**AREA WALK-BY CHECKLIST**

**Area Walk-By Checklist (AWC)** AWC-020

Seismic Walkdown Submittal Report Review Comments and Resolutions Form			
Engineering Report Number	IP-RPT-12-00039	Rev. 0	Title: Indian Point Energy Center, Unit 3 Seismic Walkdown Report for Resolution of Fukushima Near-Term Task Force Recommendation 2.3: Seismic		
Quality Related: <input type="checkbox"/> Yes <input checked="" type="checkbox"/> No		Special Notes or Instructions: N/A			
Comment Number	Section/Page No.	Review Comment	Response/Resolution	Reviewer's Accept Initials	
	AWC-01, AWC-03, AWC-07, AWC-08, and AWC-12.	SWEL component formatting is not consistent with EN-DC-168. <i>It must be SWEL1-XXX</i> AWC format needs to be AWC-XXX.	SWEL and AWC sheets have been reviewed for consistency with formatting and revised as necessary.	P.P.	
Reviewed By:	Pouria Pourghobadi 	Date	11/14/2012	Resolved By:	Paul Huebsch 
Site/Department:	IPEC/ENERCON	Ph.		Date: 11/14/2012

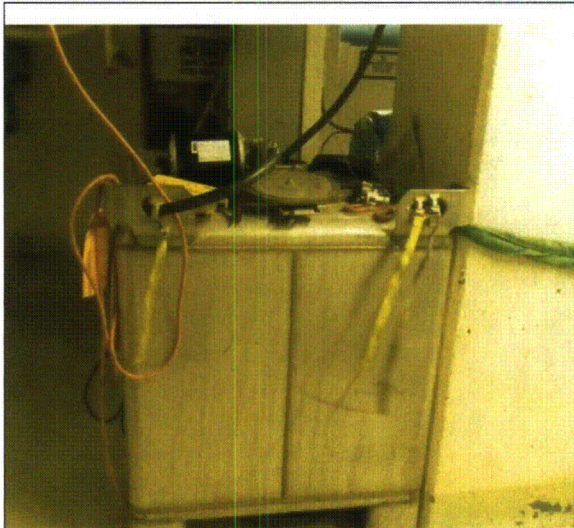
**Note:** Tools on top of CCW tank

**Note:** Tools on top of CCW tank

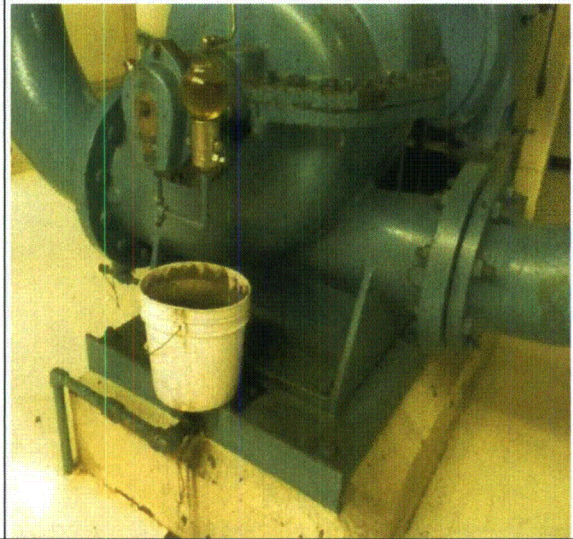
**Note:** Bucket at 32 CCW pump

**Note:** Bucket at 32 CCW pump under the oil reservoir

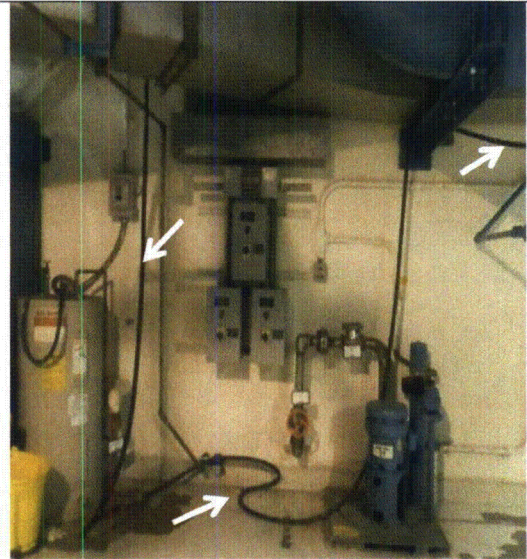
**Note:** wheeled bucket and a mop stick

**Note:** loose hose laying on floor going to an upper elevation.

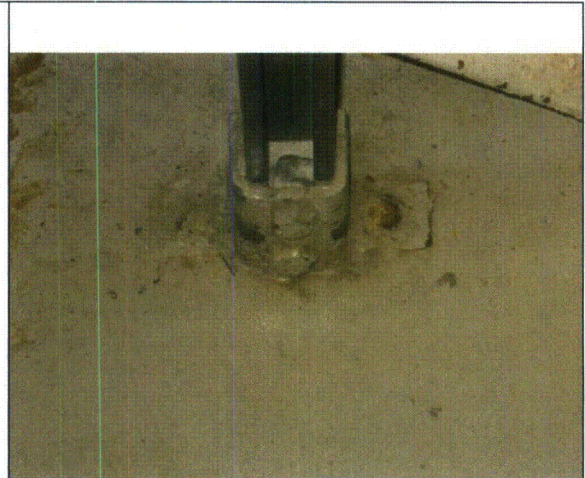
**Note:** Base plate with two out of four anchor bolts in place.

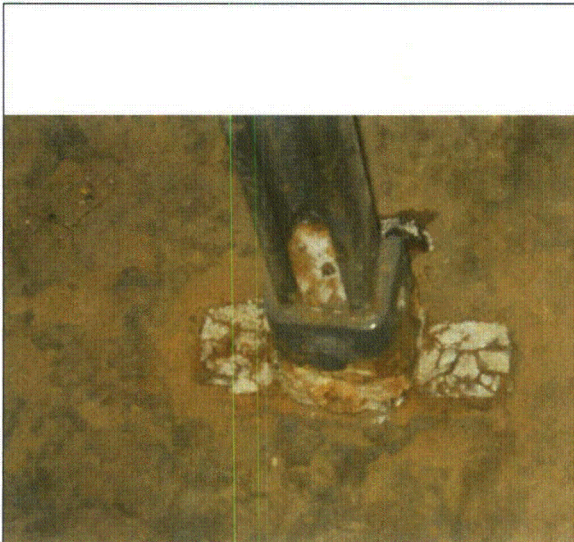
**Note:** Electric heat tracing cabinet base plate

**Note:** Electric heat tracing cabinet base plate inside of curbed area.

*Electric heat tracing cabinet support base plates and anchor bolts are severely corroded. The Unistrut support column has been welded to the stair stringer to provide additional support. CR-IP3-2012-03595 documents this condition. LB-19 has evaluated this condition.*

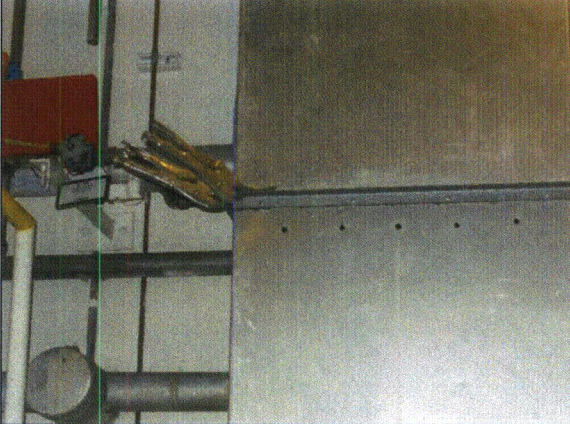
<p><b>Note:</b> Hot water heater with no apparent restraint</p>	<p><b>Note:</b> Duct work held together with vise grips</p>

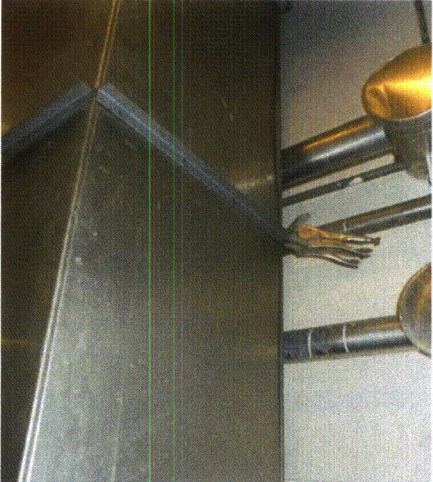
<p><b>Note:</b> Ductwork with side not connected at corner seam.</p>	<p><b>Note:</b> Pallets, drums and vacuum not secured.</p>

*The wall of the duct is light in weight and will not damage the nearby boric acid tank. In addition, total separation from the duct is unlikely; therefore, this is judged to have no adverse seismic condition. CR-IP3-2012-03595 has been written to correct these conditions.*

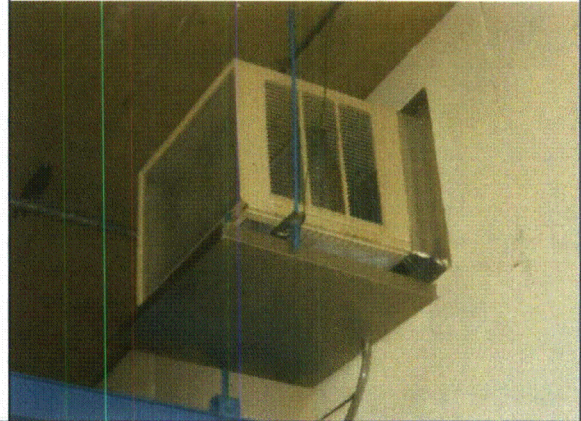
**Note:** Pipe hanger in close contact with horizontal pipe.

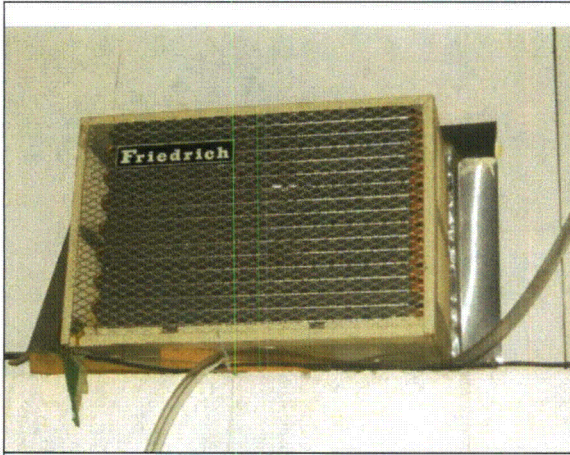
**Note:** Air conditioner with no apparent horizontal support.

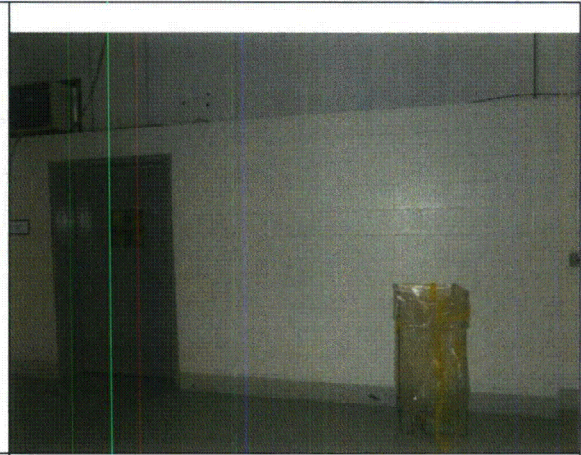
**Note:** Air conditioner with no apparent lateral support

**Note:** Masonry wall at office section

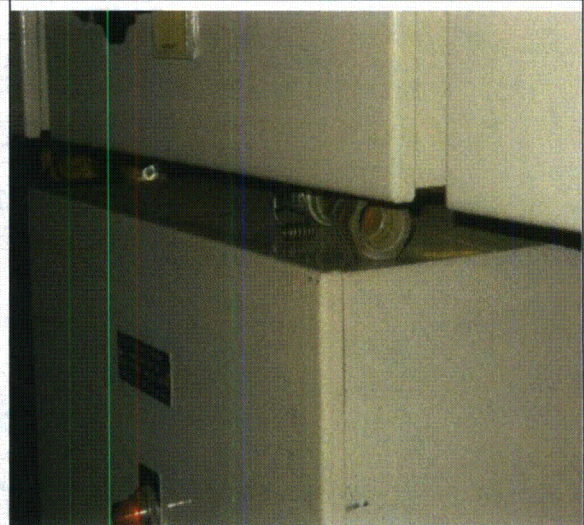
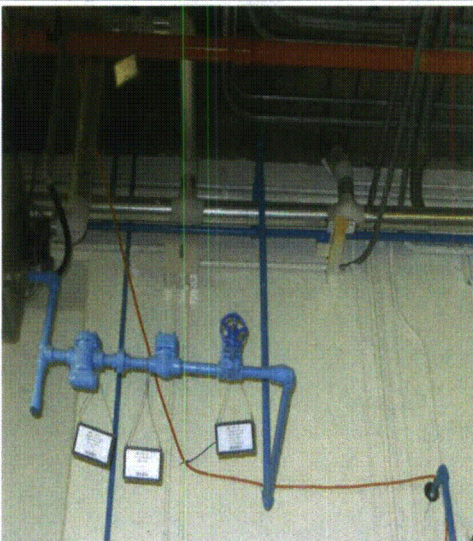
**Note:** Screw driver left on Unistrut

**Note:** Miscellaneous parts on top of panel

**Note:** Area heater UH334 piping not seismically supported

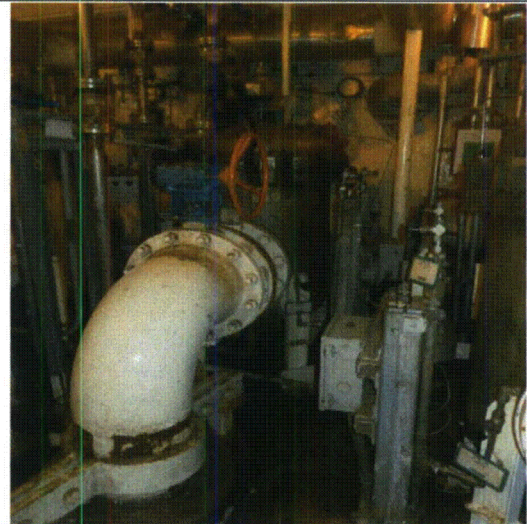
**Note:** Anchor bolt for strainer (stainless steel) with some corrosion of base angle.

**Note:** View of piping at strainer

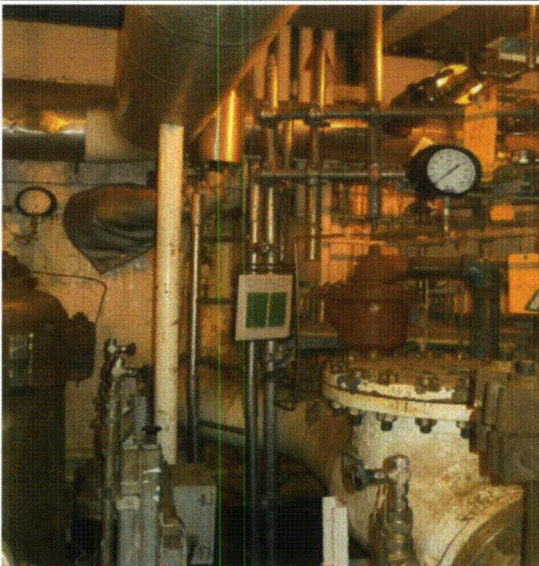
**Note:** Scaffolding adjacent to strainers with green tag.

**Note:** Corrosion at the base of a Unistrut column

*Nearby Unistruts for panels and stanchions for pipe supports show varying signs of advanced corrosion. CR-IP3-2012-03633 has been written to remedy the condition for the stanchions. EC-38453 was generated to repair DPIC-1111 and DPIC-1113 thru 1116 racks. EC-28998 was generated for the corroded IA supports.*

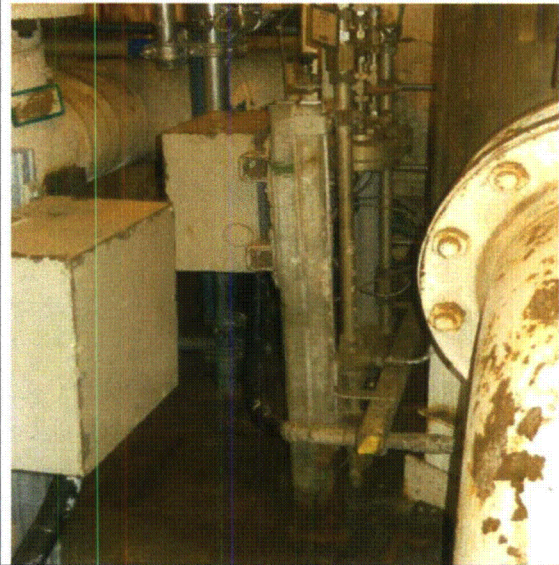
**Note:** Corrosion at the base of a Unistrut column

**Note:** Unistrut column which is beginning to tilt

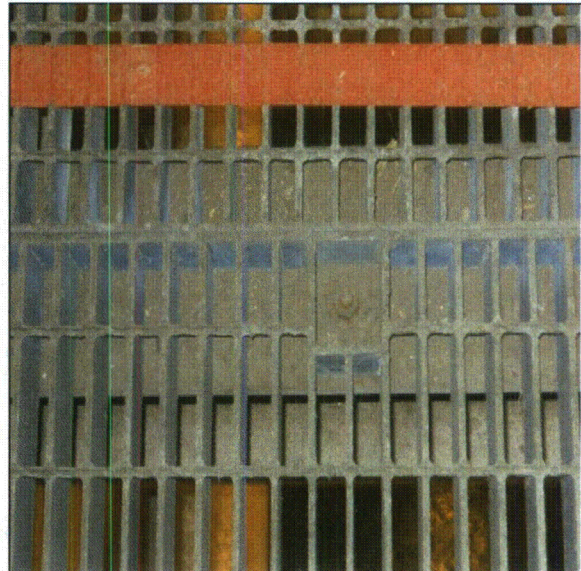
**Note:** Pipe support stanchion showing considerable corrosion

**Note:** Grating forming the ceiling of the room is well secured to the support steel

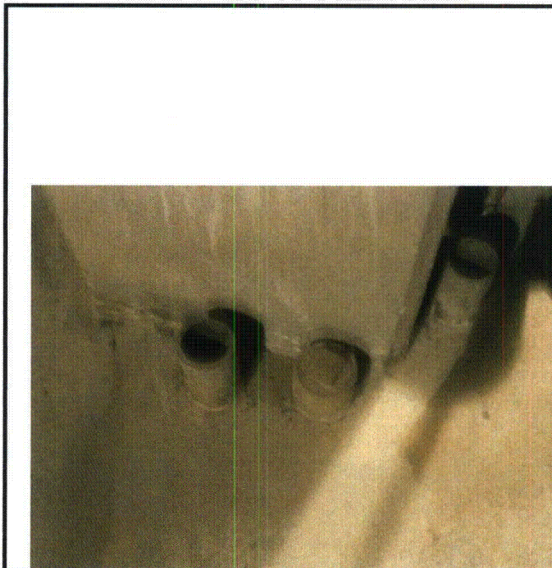
**Note:** unrestrained ladder by the north wall.

**Note:** unrestrained ladder by the door at the south corner of the room.

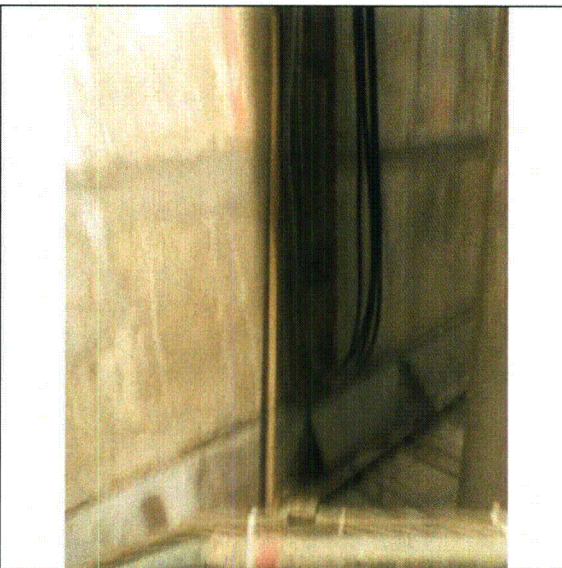
**Note:** Loose plug and unplugged piping.

**Note:** unrestrained broom stick

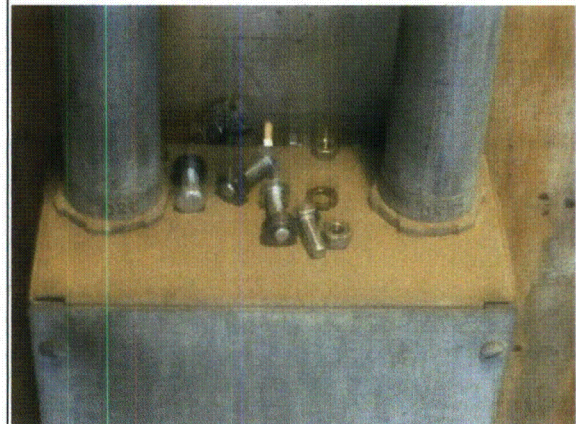
**Note:** Broken flashing

**Note:** Missing flashing along the wall

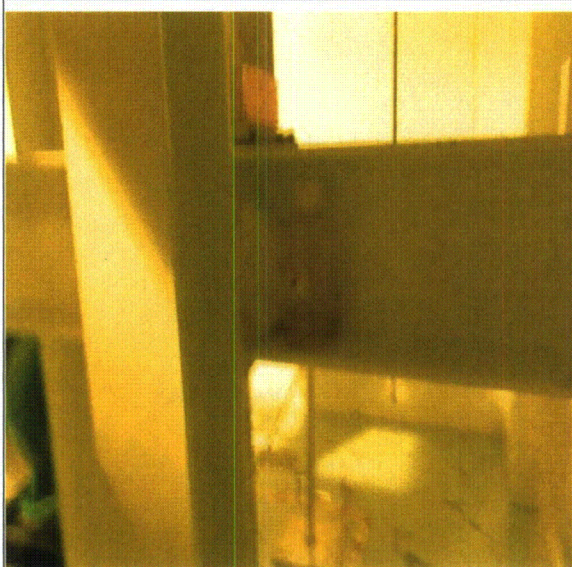
**Note:** bottle sitting on a beam

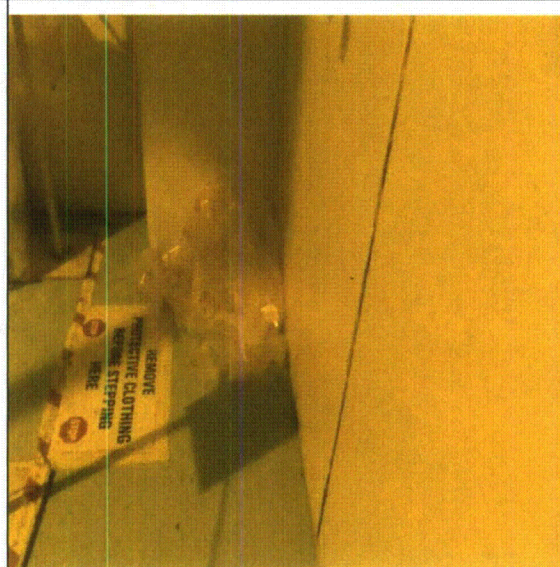
**Note:** waste bag on the floor

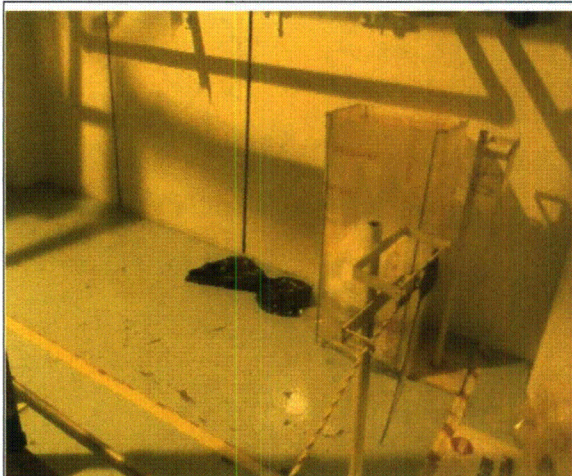
**Note:** waste bag on the floor

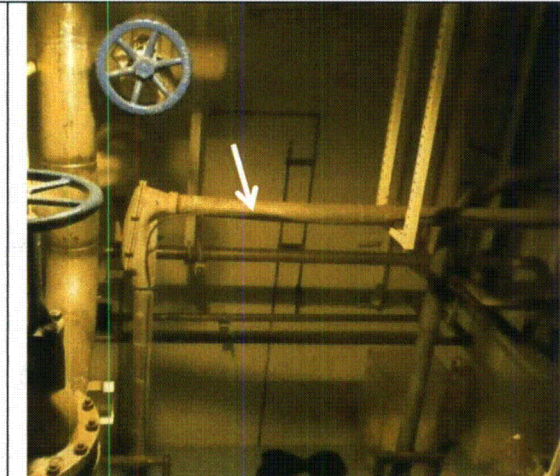
**Note:** bare wire attached to a conduit

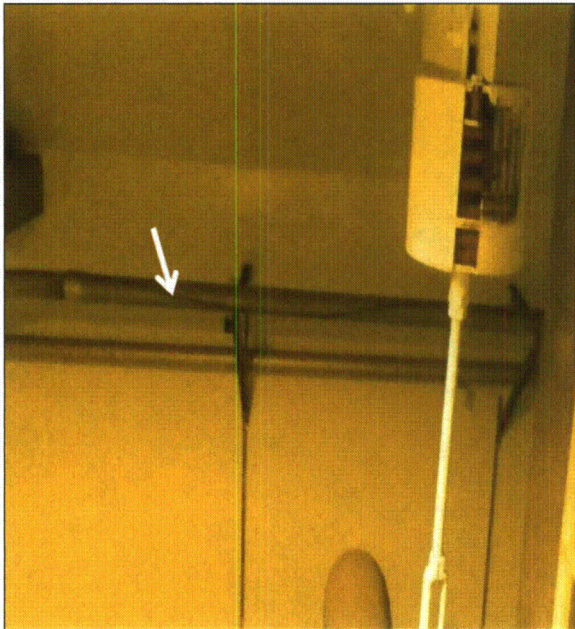
**Note:** bare wire attached to a conduit

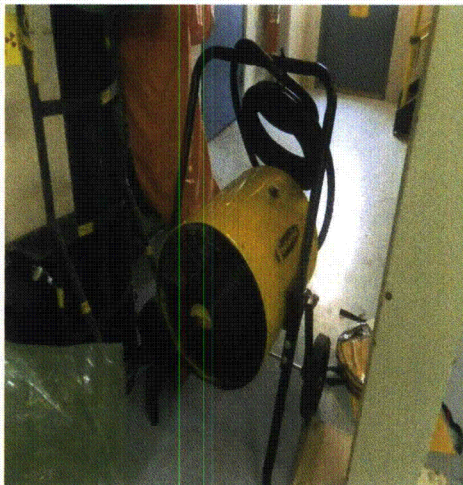
**Note:** Waste bucket on top of a Boric Acid container

SWEL1-070

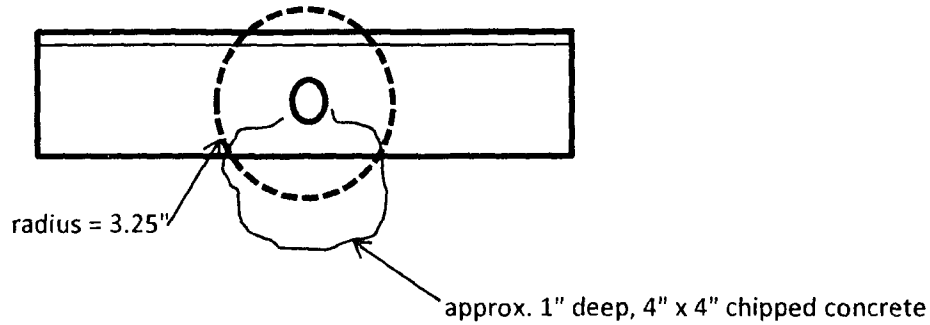
A 1" deep, 4"x4" chip concrete area adjacent to Hilti bolt

The 1" deep concrete chipped area is conservatively treated to cover 35% of the shear cone area for a 3.25" embedment expansion bolt. The 1" deep, chipped area still has capacity and can be considered as 35% of a shear cone area of a (3.25"-1") = 2.25" embedment anchor.

**AWC- 27**

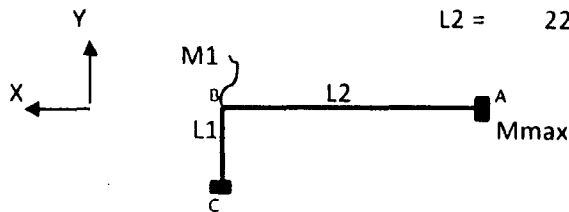
Liquid Waste pipe has 25' to 30' span length

D = pipe outside diameter =	4.5	inch
t = wall thickness for sch 40 pipe =	0.237	inch
S = section modulus of 4" Sch 40 pipe =	3.21	in <sup>3</sup>
w = uniform weight of pipe and water =	16.3	plf
P = design pressure =	150	psi
i =SIF of 4" LR elbow =	1.95

AWC- 12

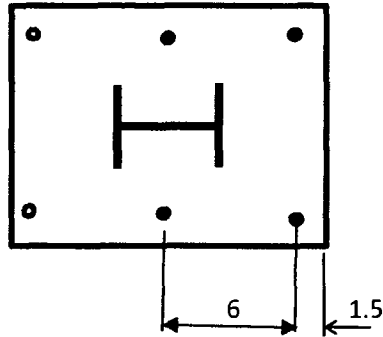
PWR-599 has only 4 anchor bolts instead of 6

Stress interaction at Hilti bolt and plate stress are below the acceptable limit.
